Product Change Notification

Change Notification #: 113356 - 00
Change Title: Intel® Server System R2312GZ4GC4
PCN 113356-00, Product Design
Update the System Rear Panel and
BIOS/ME/BMC/FRUSDR Firmware
Date of Publication: October 28, 2014

Figure One

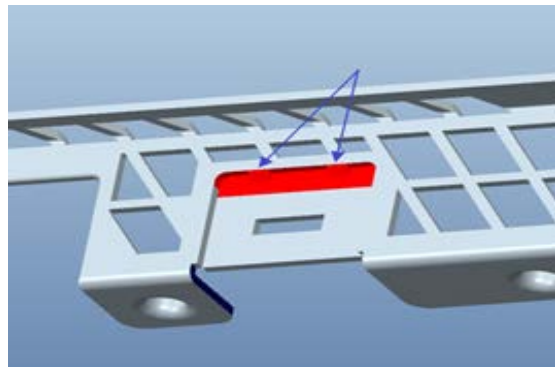
1. Update the one big center joint to two smaller joints so that the joints will not conflict with the LAN cable connector latch. See the Figure One.

Figure Two

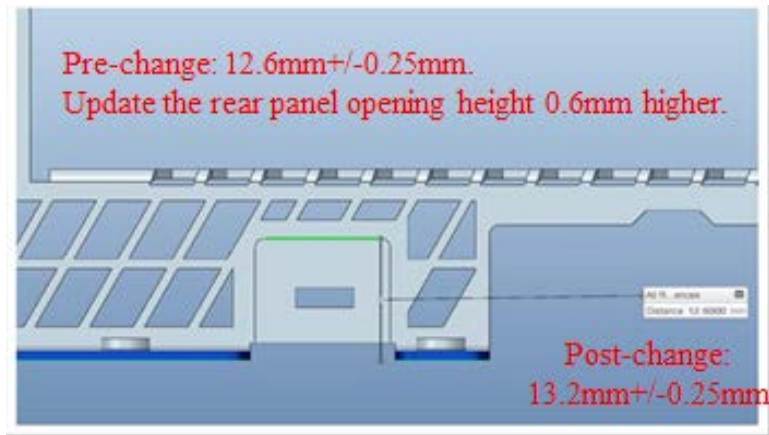
2. Update the rear panel opening height 0.6mm higher to improve the flexibility for the cable latch. The previous height was 12.6mm \pm 0.25mm. The updated height is 13.2mm \pm 0.25mm. See the Figure Two.

Figure Three

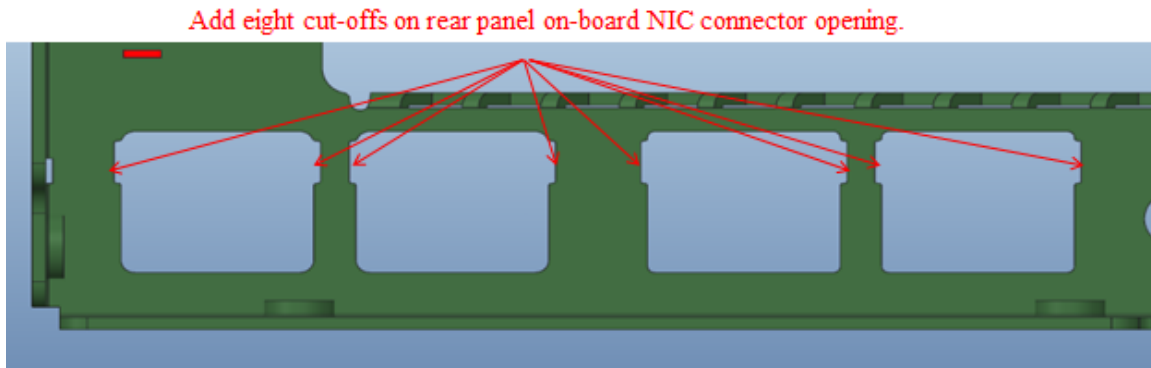
3. Add eight cut-offs around the on-board NIC (Network Interface Controller) openings to improve the LED visibility. See the Figure Three.
